SERVICE BULLETIN

INSPECTION/MODIFICATION OF BREEZE CORPORATION INC HOIST, PN BL-16600-12

The information given in this Service Information Notice lists procedures for inspection and modification of Breeze Corporation Inc. hoist, PN BL-16600-12, which is a component of the rotorcraft hoist system. This inspection/ modification is to be accomplished in accordance with the, instructions given in the attached Breeze Corporation Inc. Engineering Bulletin BEB-162-8.

CHPILED	D.B.	5/4/80			RATIONS NJ USA		BEB-16	2-8	Page 1 of 7	•
HECKED			TITLE:				ue Hois	+		
HOJ ENGR	Felber						n and Mo		cation	
NCBG APP	Italher	5/21/80			_			CODE	E NO. 08484

FIGURE 1 EQUIVALENT:
ESSO-BEACON 325
AMOCO - SUPER-MIL

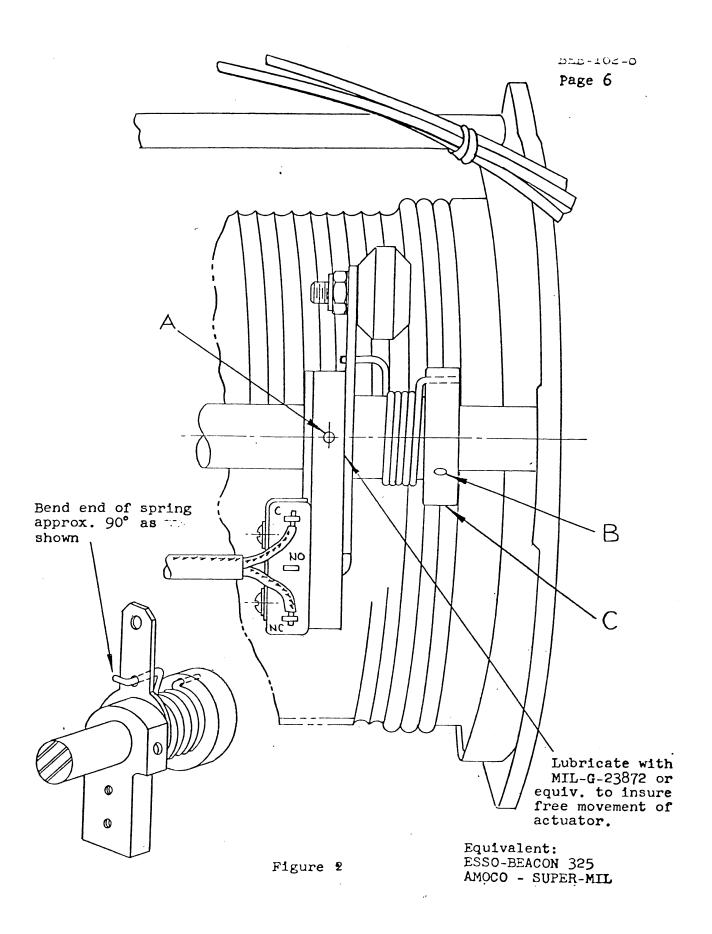
- Switch assembly must be positioned on cross bar so as to allow switch roller to contact grooved surface of drum immediately adjacent to inactive cable wraps (2 1/2 to 3 1/2 wraps). This may be accomplished by loosening both sets of socket head screws (A and B, Fig. 1) in both collar assemblies. The switch assembly may then be slid across the bar to the desired position. Tighten the socket head screws to 4 in. lb. End clearance in the assembly must be maintained at .002 to .005 to allow proper movement of roller arm. (C, Fig. 1)

- With roller resting on grooved portion of drum adjacent to the proper number of inactive turns (2 1/2 to 331/2) loosen socket head screws (A, Fig. 1) and rotate switch until it can be heard to actuate. Tighten socket head screws to 4 in. lb. Again, end clearance must be .002 to .005 for proper operation.

- 3. Bend end of spring per Fig. 1.
- Check hoist for satisfactory operation.
